<b>sabena</b> B707	Module: GENERAL	A/C Reg :	Check :	 06G200001 Page 2 of 12
	Oper. : PROC.	Issuer : A62165	Cert.St.: 50516	
	Type : MODIF	Release Date: 02.04.2010		
Spec. : ELECTRICIAN

DFW B707-49-001 rev 1      APU BATTERY CHARGER REPLACEMENT

## ENGINEERING INSTRUCTION

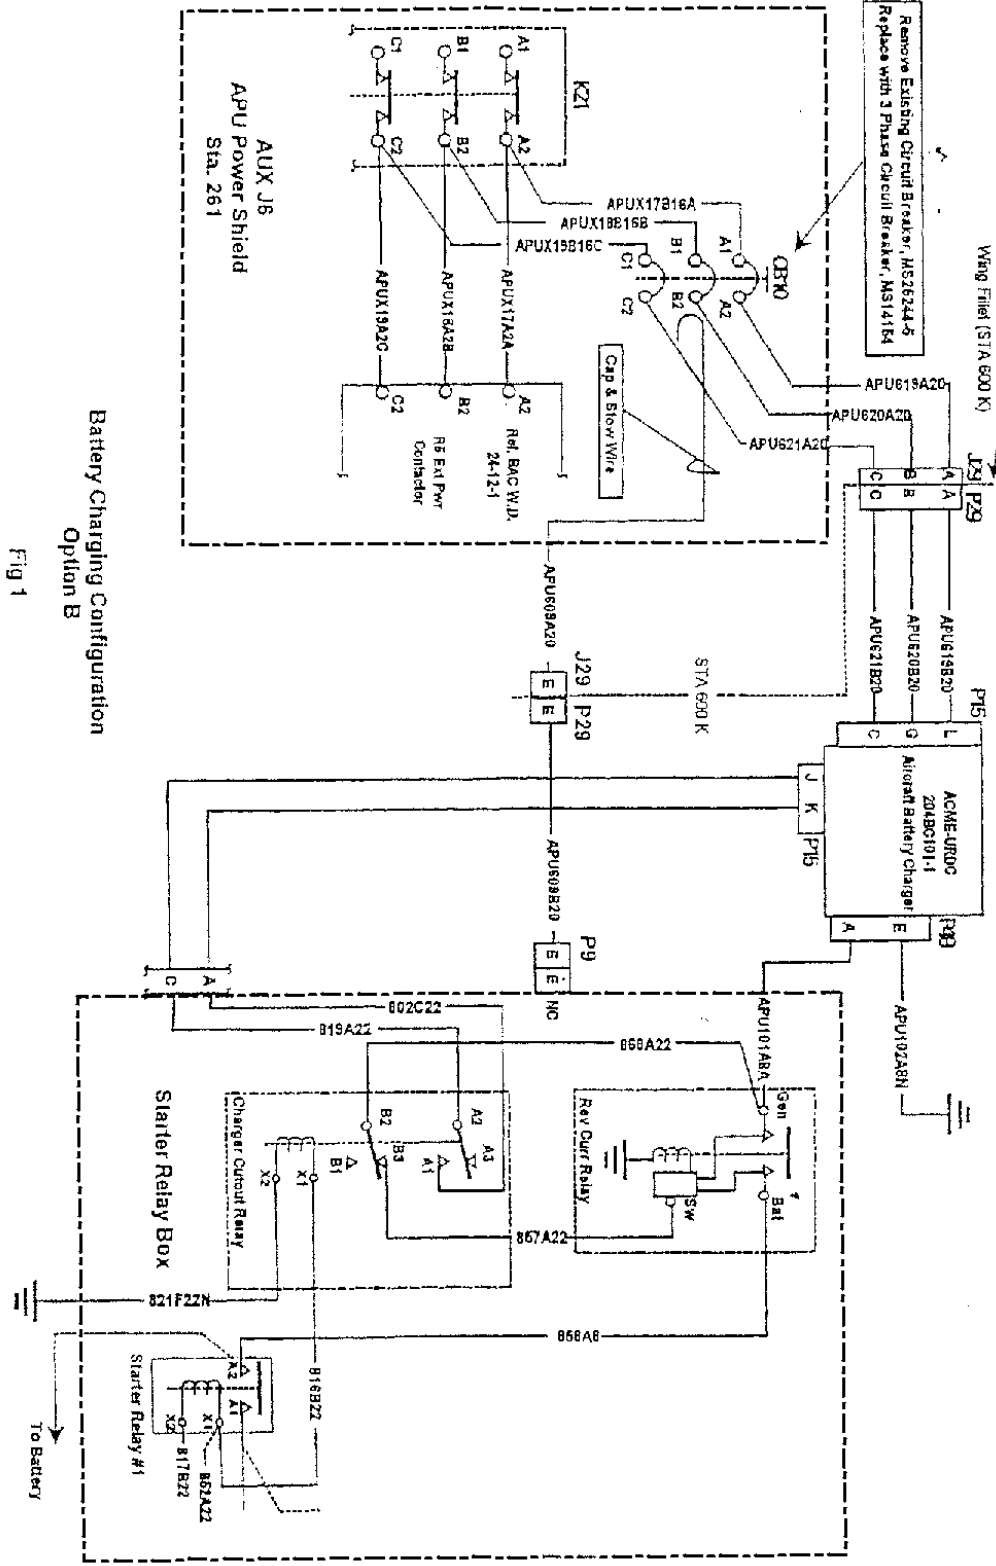
MAINT	RII/INSP
Nr.	Hardtime	Task	Spec.	Related Documents		
1.		MOD	REI	DFW B707-49-001 rev 16 feb 2010		
<b>Check:</b>						
<b>Zones:</b>						
<b>Access:</b>						
NRC YES <input type="radio"/> NO <input type="radio"/>		IF YES, NUMBER(S):				
<b>REPLACEMENT OF SDI BATTERY CHARGER WITH AN ACME-URDC CARGER (REF TO FIG.1)</b>						
<b><u>A. CONDITIONS:</u></b>						
<b><u>CAUTION:</u></b> Keep the work area, wires and electrical bundles clean of metal particles or contamination when using tools. Unwanted material, metal particles or contamination caught in wire bundles can cause damage to the bundles. Damaged wire bundles can cause sparks or other electrical damage.						
<b><u>NOTE:</u></b> 1- Obey all warnings and cautions given in the specific manual sections. 2- Refer to the Boeing Standard Wiring Practices Manual D6-54446 chapter 20-10-11 and 20-10-12 for the wire installation procedures.

1. Remove electrical power from airplane. Use independent power source for the work lights.						
<b><u>NOTE:</u></b> Item numbers used in the worksteps below are related to the material list at page 12. For clarity, the references to the partslists on the Steward Davis drawings are also provided.						
<b><u>B. PROCEDURE:</u></b> (SEE FIG FOR LOCATION)

1. Access APU starter relay box at STA 960L lower lobe.						
a Remove existing charger controller P/N 2131 SD Mod CVR (ref. drawing 90513 item 13), WD 49-41-02 before modification.						
b Locally manufacture relay bracket item1 per drawing 92513 issue org.						
c Install relay bracket item 1 per drawing 92513 issue org. using Items 2, 3, 5, 13 and 31 (ref. drawing 92513 items 83, 45, 84, 69 and 25).						
d Install 4 nutplates item 6 per drawing 92513 issue org (ref. drawing 92513 Item 52) using item 7 (ref. drawing 92513 item 26).						
e Install battery reverse current relay item 10 (ref. 92513 Item 13) per drawing 92513 issue org. using item 9 und item 8 (ref. 92513 Items 43 and 53).						
f Remove capacitor P/N 67201-101-6 (ref. 92513 item 74) per drawing 92513 issue org.						
g Locally manufacture battery charger CB bracket item 11 (ref. 92513 item 81).						
h Install battery charger CB bracket item 11 per drawing 92513 issue org., using item 12 and item 4 (ref. 92513 items 6 and 25).

APU STARTER RELAY BOX  
7804 THRU 7900  
49-41-02/35060  
PAGE 1

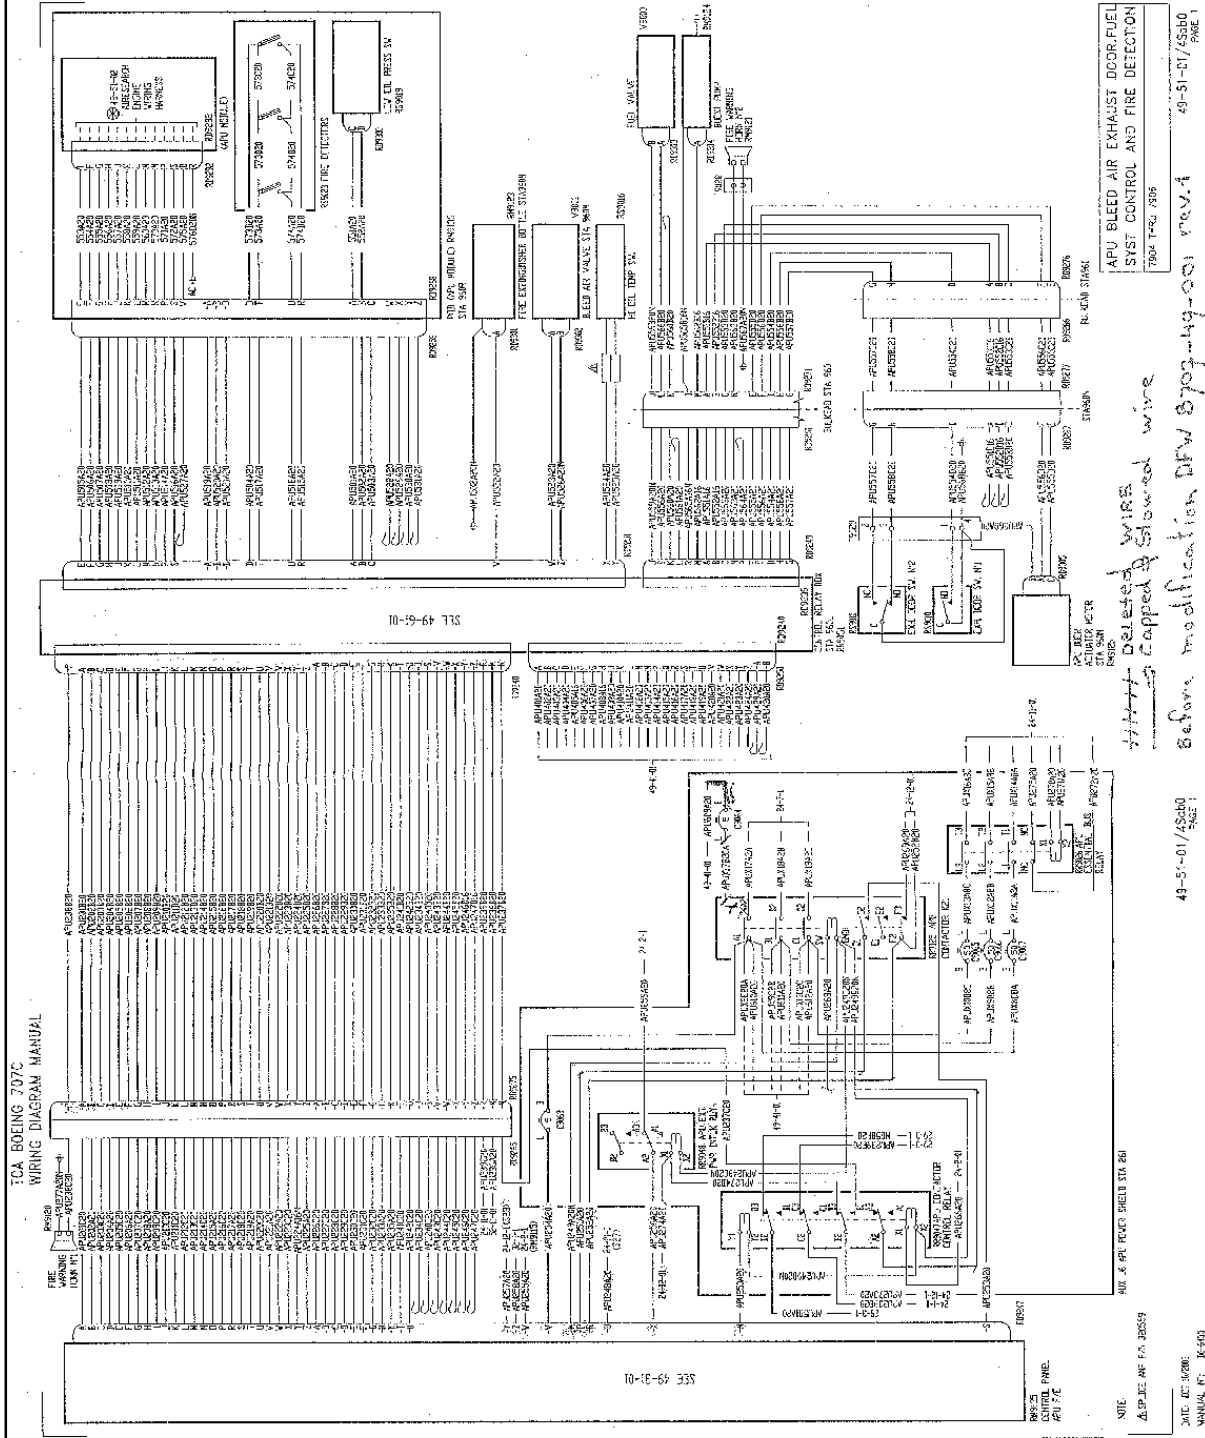
Before DFW B707-49-001 Rev.1

Removed wires  
Re-terminate wires
